HISTORIC AND DESIGN REVIEW COMMISSION

HDRC CASE NO: 2022-051
ADDRESS: 419 N MONUMENTAL
LEGAL DESCRIPTION: NCB 1373 BLK 1 LOT 33
ZONING: H
CITY COUNCIL DIST.: 2
DISTRICT: Dignowity Hill Historic District
APPLICANT: Manuel Almar/Manuel Almar
OWNER: Manuel Almar/Manuel Almar
TYPE OF WORK: Exterior modifications, construction of a rear addition, fenestration modifications, porch modifications, window replacement, fencing
APPLICATION RECEIVED: February 18, 2022
60-DAY REVIEW: Not applicable due to City Council Emergency Orders
CASE MANAGER: Edward Hall

Historic and Design Review Commission
Design Review Committee Report

REAR ELEVATION

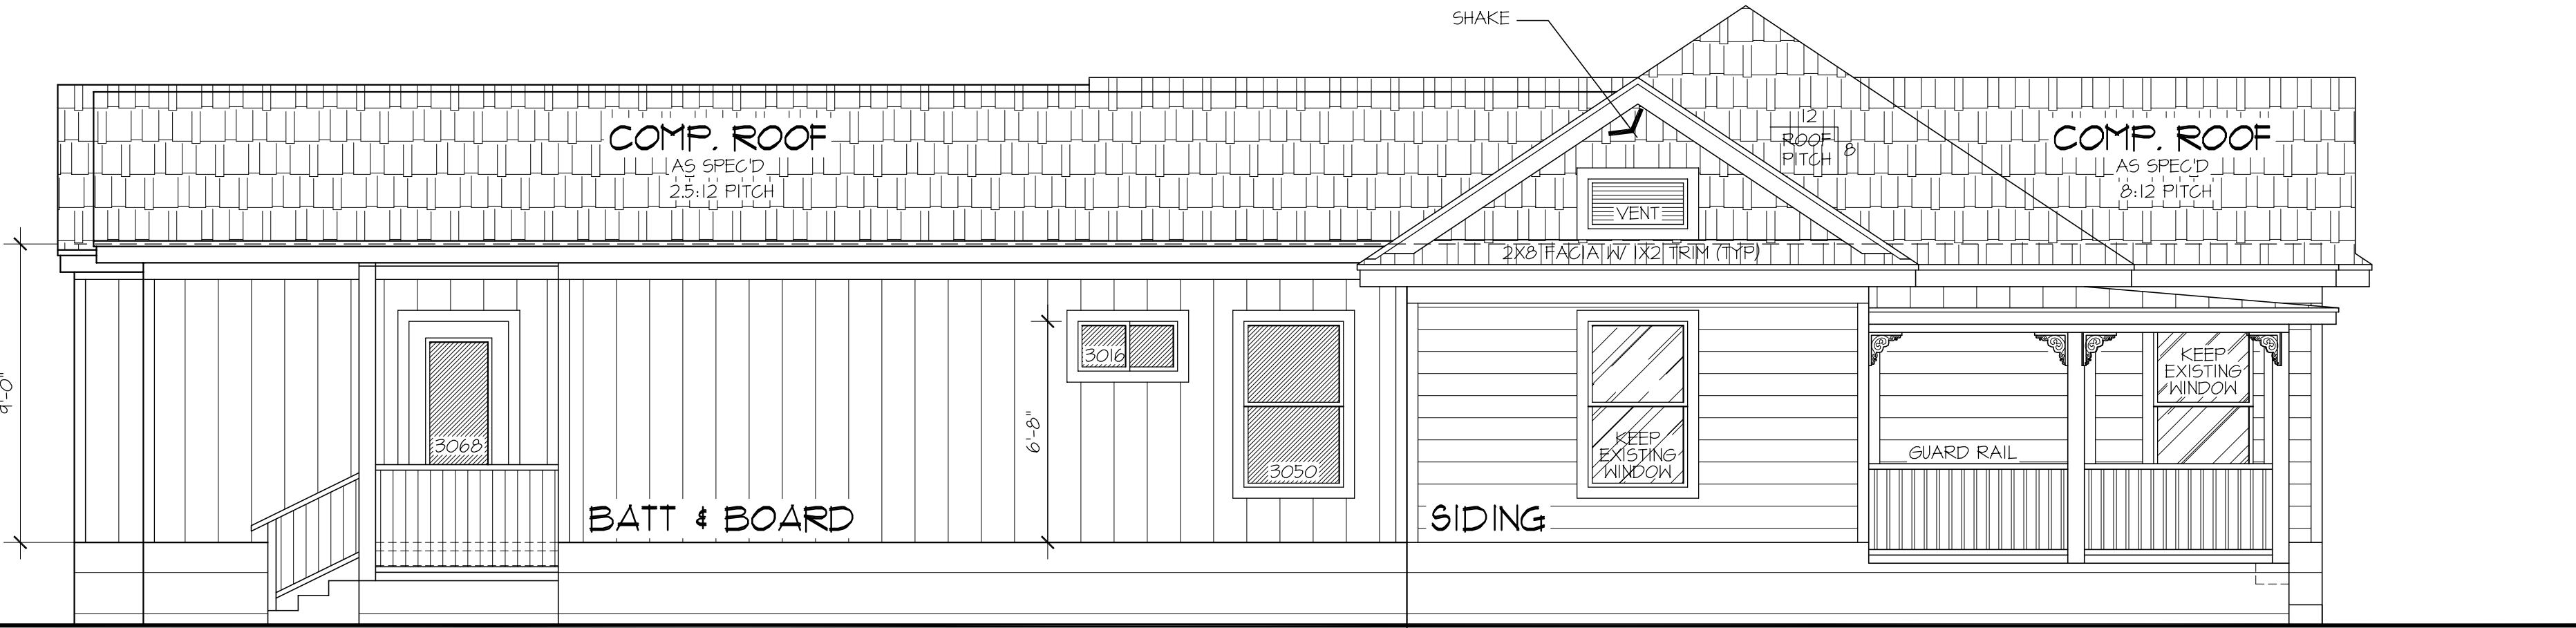
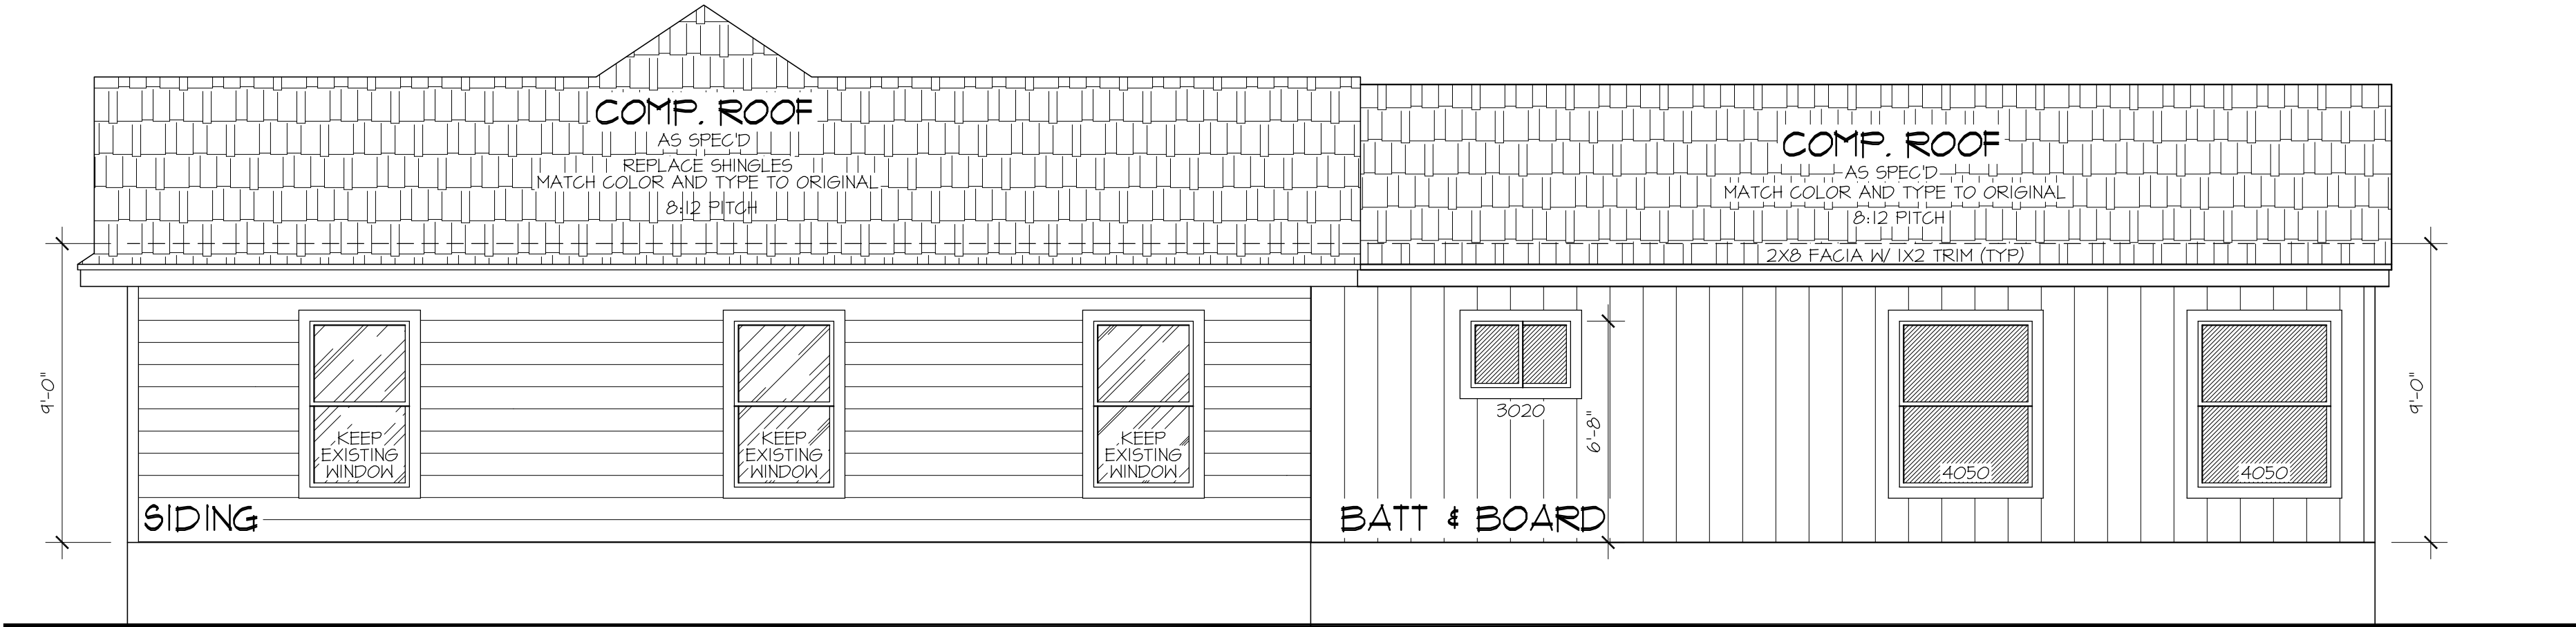
- n. ROOF FORM – The applicant has proposed for the rear addition to feature a rear gabled roof with an uncentered ridge line resulting in a long, low slopes profile to the south. The Guidelines for Additions 2.A.iii., roof forms should utilize similar roof pitch, form, and orientation as the principal structure for additions, particularly for those that are visible from the public right-of-way. Staff finds the proposed roof form of the addition to be inconsistent with the Guidelines.

- o. ARCHITECTURAL DETAILS – As noted in finding m, staff finds that the proposed addition should feature a roof form that is consistent with the Guidelines. Additionally, staff finds that all window openings should be consistent with the Guidelines, and that contemporarily sized windows should be eliminated for traditionally sized windows.

MS: The general updates seem to work on paper; however, the asymmetrical gable/shed portion looks a bit odd.

- iii. That the applicant modify the proposed roof form to feature a rear gable that features a centered ridge line to result in a gable with equal slopes of both sides.

- iv. That the rear addition feature traditionally sized windows with a one over one profile and that all rectangular windows be modified to feature traditional sized. Large, picture windows should be modified to feature openings that are consistent with the historic structure's original openings.

ROOF PLAN

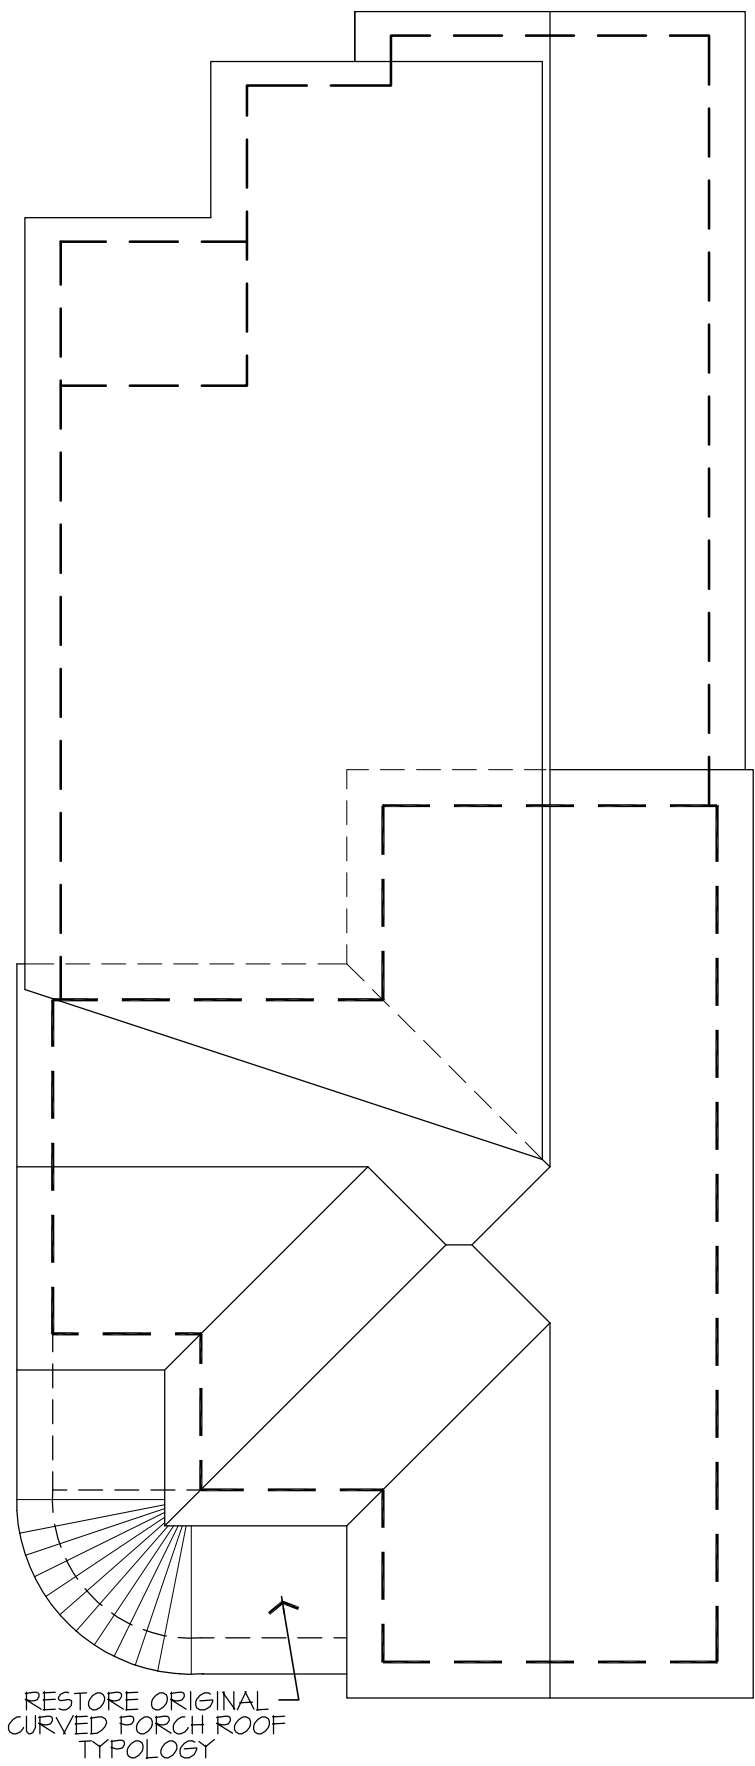
- f. ROOF REPLACEMENT – The applicant has proposed to replace the existing, shingled roof with a new shingled roof. Staff finds the proposed replacement to be appropriate provided that all original roof forms and architectural details associated with the original roof form are preserved.

1. Staff recommends approval of item #1, roof replacement based on finding d with the stipulation that all original roof forms and architectural details are preserved.
